Product Information

PAP PIN timber IV87 treshold

Roto Patio Inowa

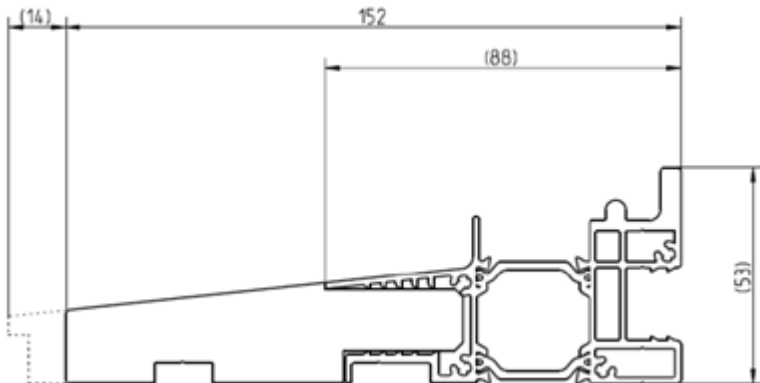
Treshold mat. 895678 and 895679 were removed from the program. A modified replacement is available.

When using the Leitz IV78 profile system, the front edge (Purenit) of the front (Purenit) of the treshold 814892 / 814893 must be cut off by 14mm (see sketch below).
